Service Bulletin

No. : MZ02-032

Model: SR5200/SR6200/SR7200

Subject: Pop noise

* Version 1 P.C.Board (7020 06076 001-0) : Please apply the modification mentioned below (Page2 to 4).

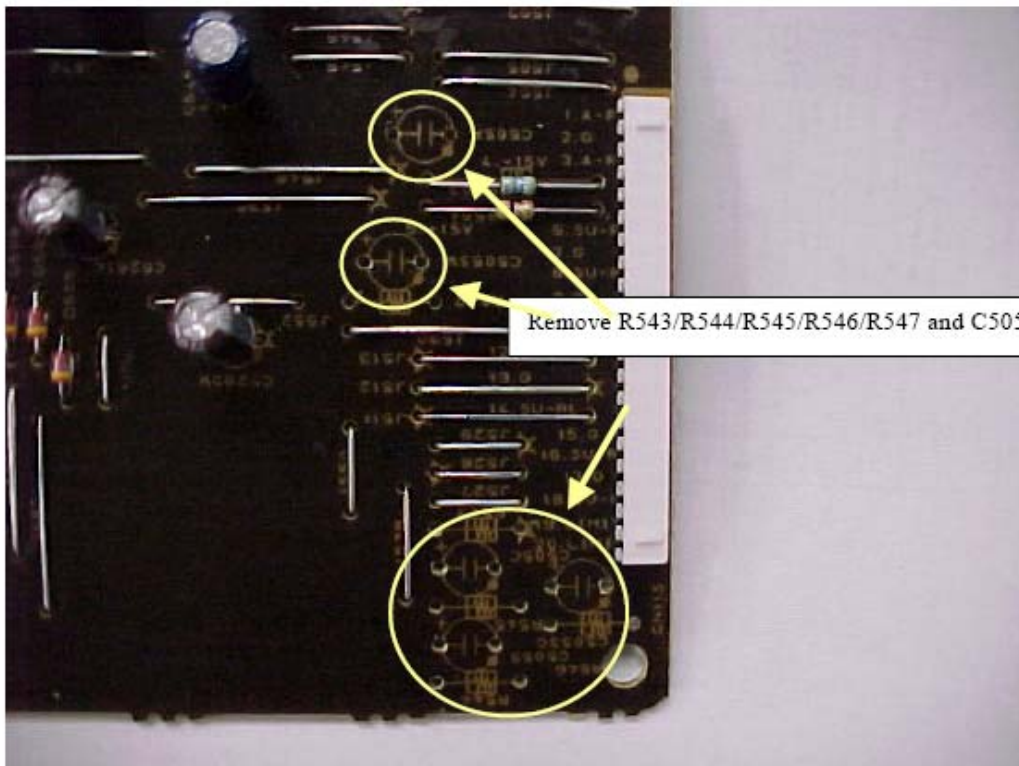
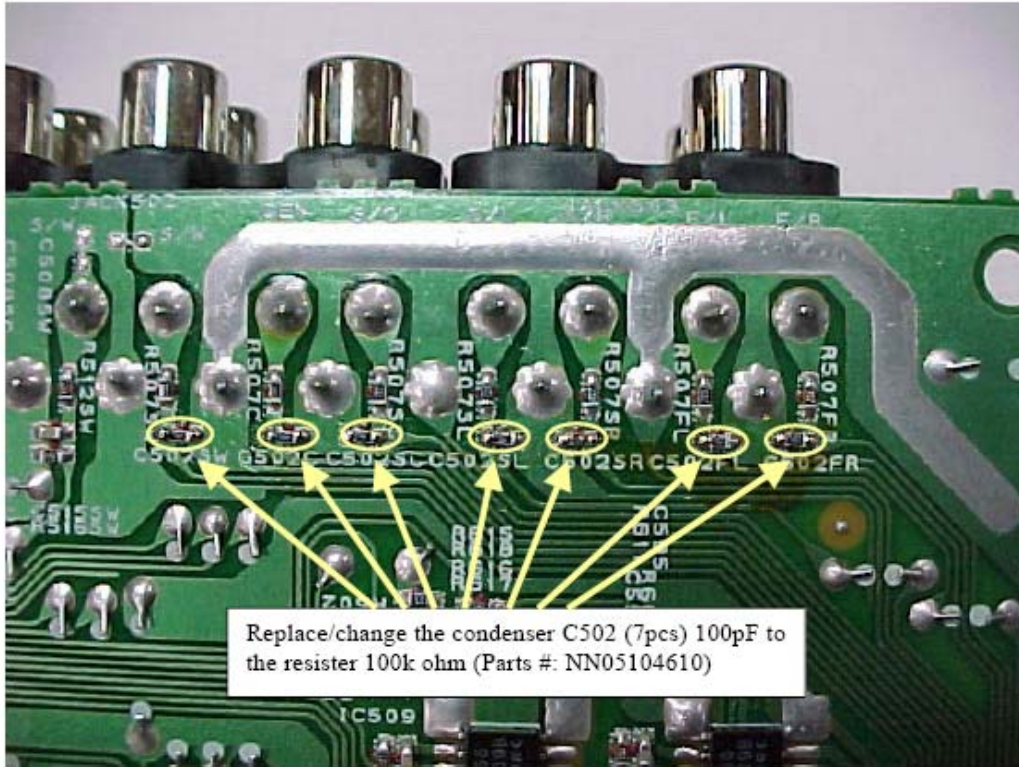
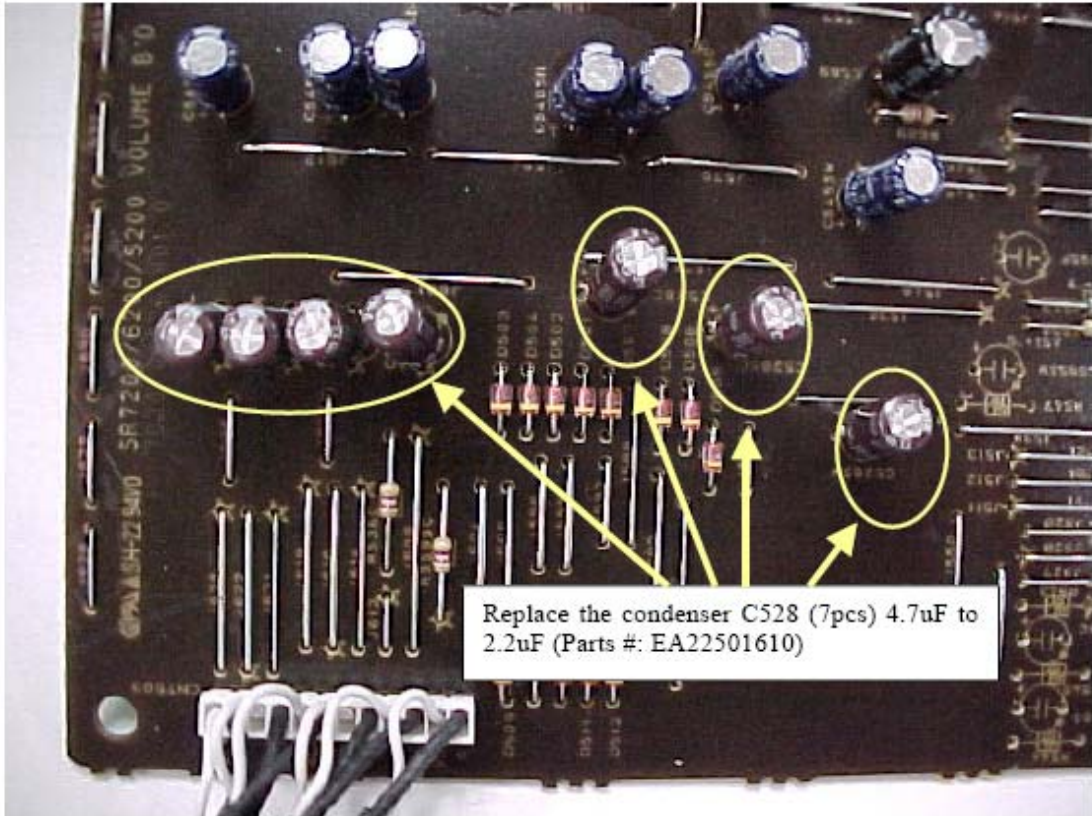
Symptom: A pop noise appears when you stop playing or skip tracks on CD playback when using a Digital connection. Pop noise appears when the Main volume is changed 74dB to 75dB (Mute).
